ADDENDUM NO. #2
City of Troy, IL
Kimberlin Street Retention Pond

KIMBERLIN STREET
RETENTION POND
CITY OF TROY, IL
DRAINAGE PROFILES

EXP: 11/30/27
PROJECT NO.: 225007.011
DATE: 02/17/2026
ISSUING TITLE: DRAINAGE PROFILES
DRAWING NO.: C3.2

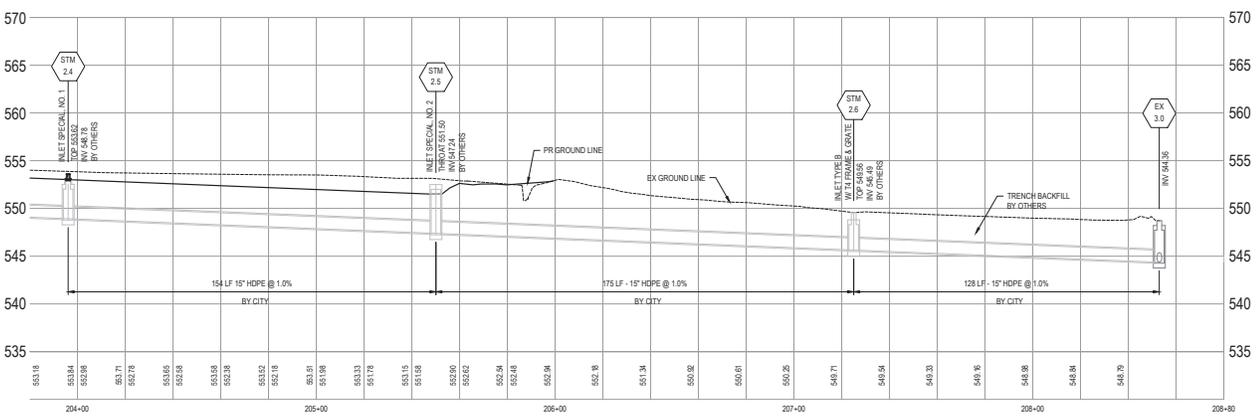
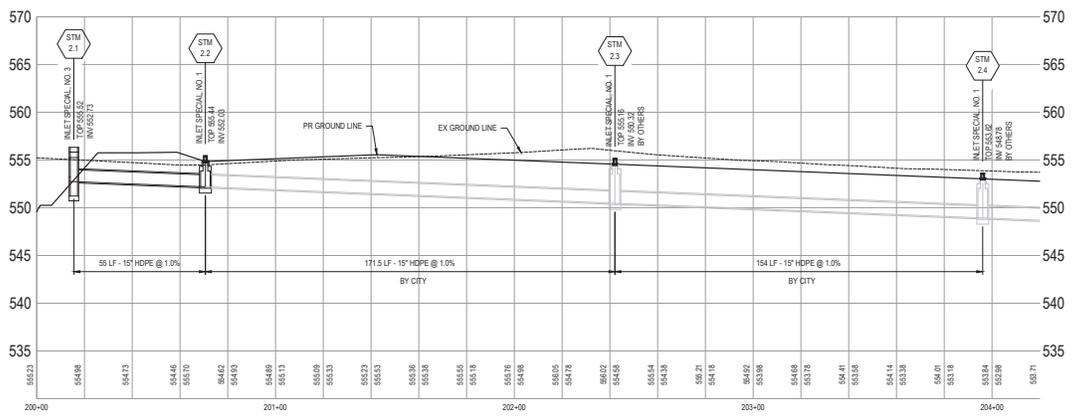
1. Replace Sheet C3.2 of the plan set with the sheet provided. HDPE pipe is now specified on the drainage profiles.
